Addendum No: 2
 Date: April 29, 2024
 Owner: Northern Health
 Stantec # 144320012

This addendum is to be read with and constitutes part of the tender document.

2.1 Drawing M002:

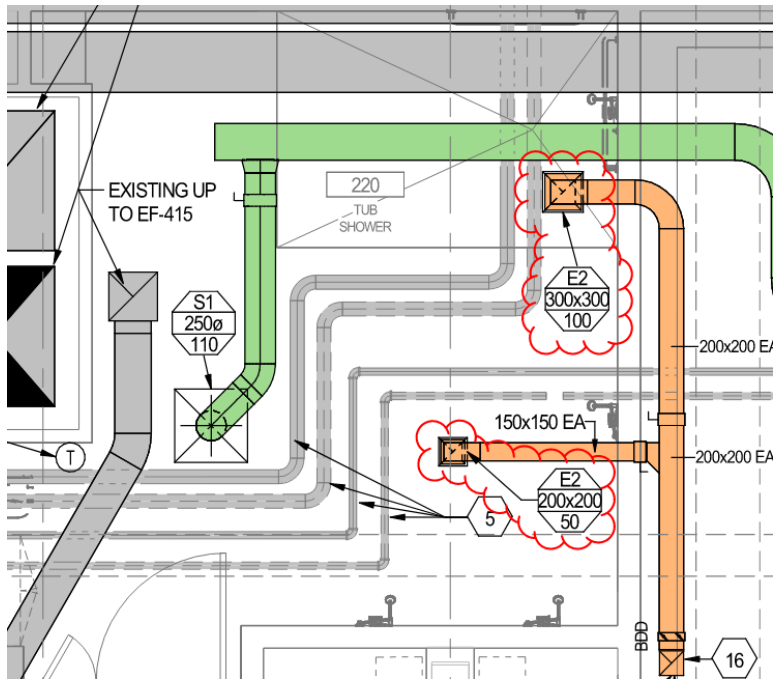
ADD: Add E2 (E.H.Price, 630 Aluminum exhaust grille) to air terminal schedule as clouded in below.
 Revise: General note A in air terminal schedule to *“Confirm with architectural ceiling plan for air terminal sizes if they are metric or imperial conversion.”*

2.3 Drawing M101:

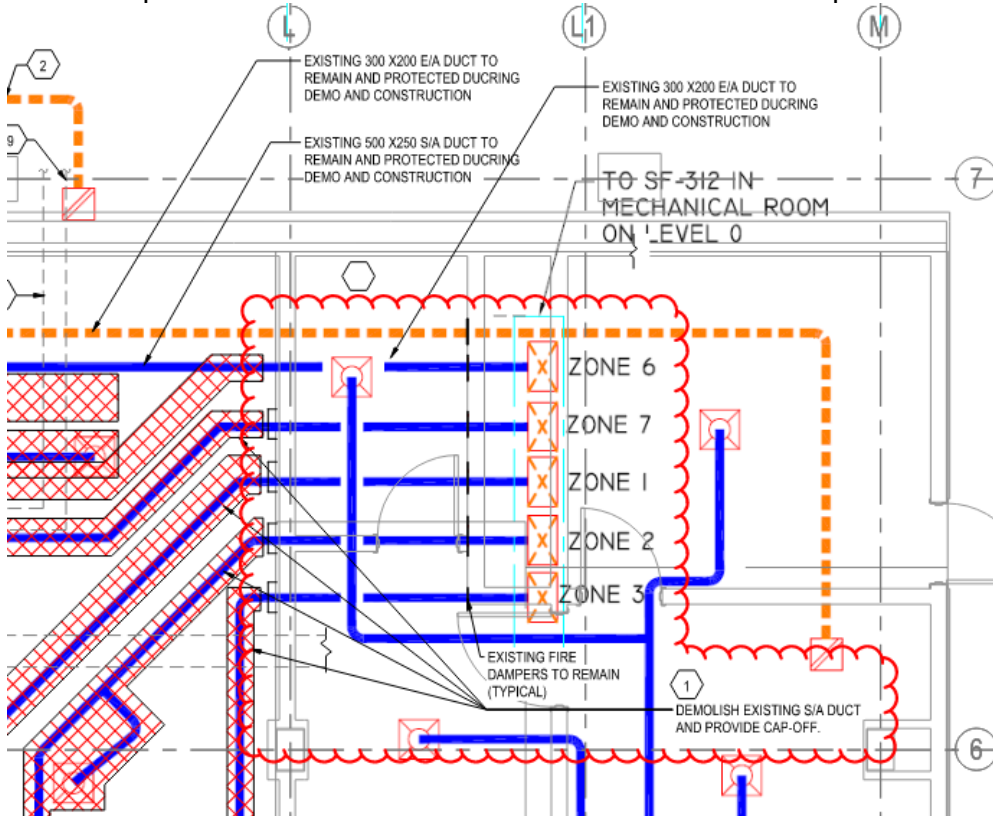
UPDATE: The existing supply air ducts on the right side of GL. L (Between GL. L and L1) to remain. Provide cap-off to the left of GL. L as shown clouded in below snip.

2.3 Drawing M200:

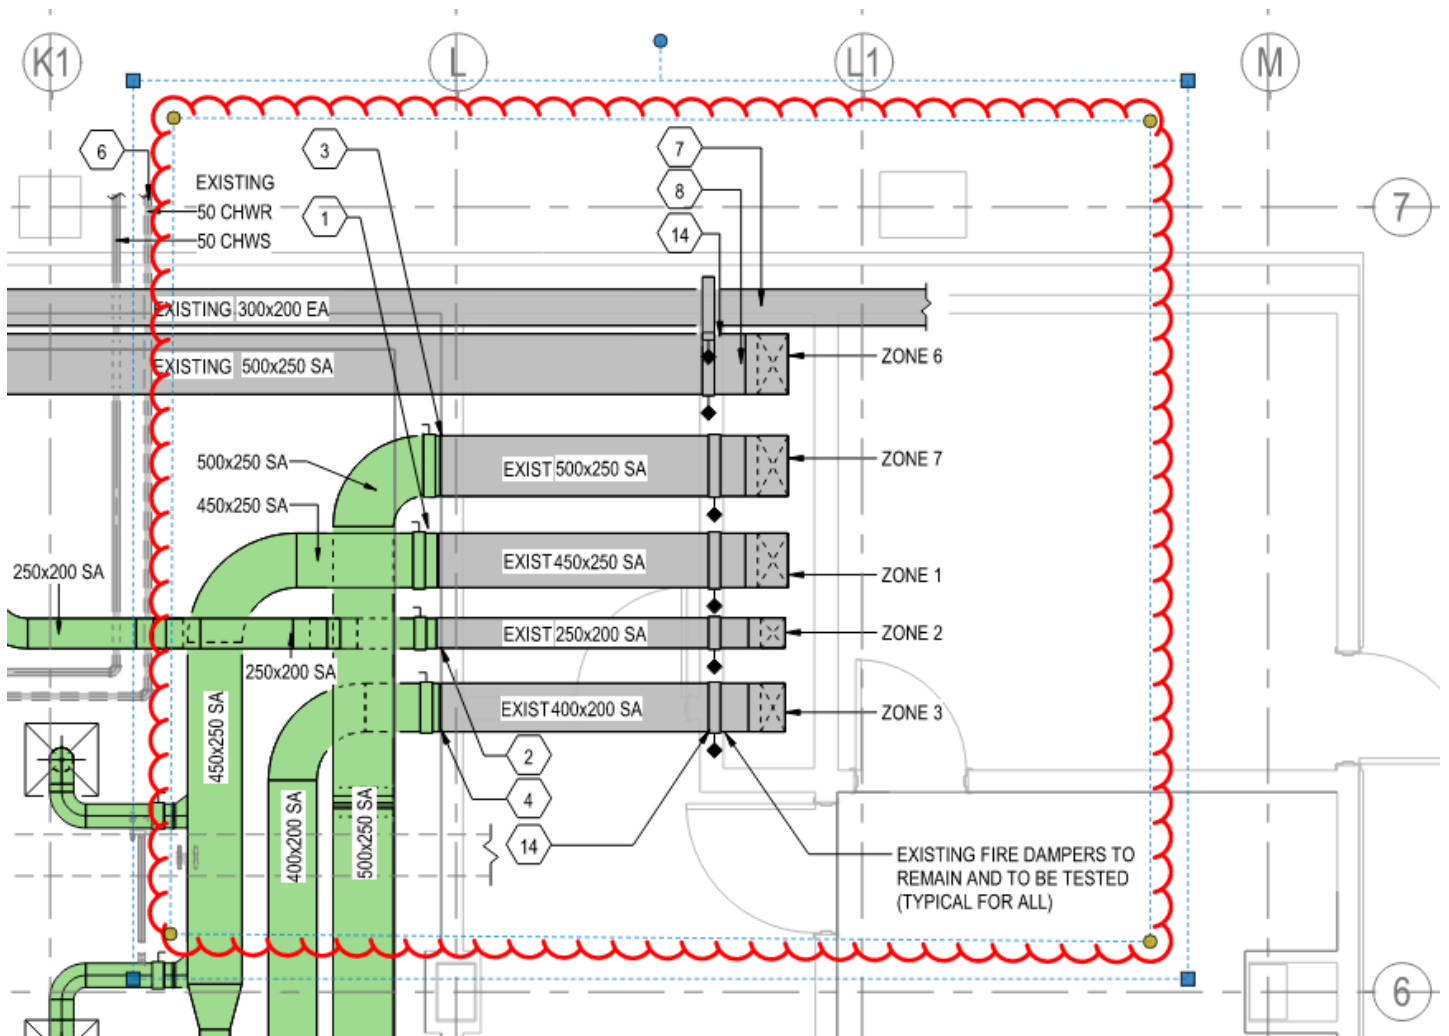
UPDATE: Connect new supply air ducts to the existing supply air ducts at GL. L as shown clouded in below snip. Revise Keynote 14 to “Existing fire dampers to be tested (typical)”.
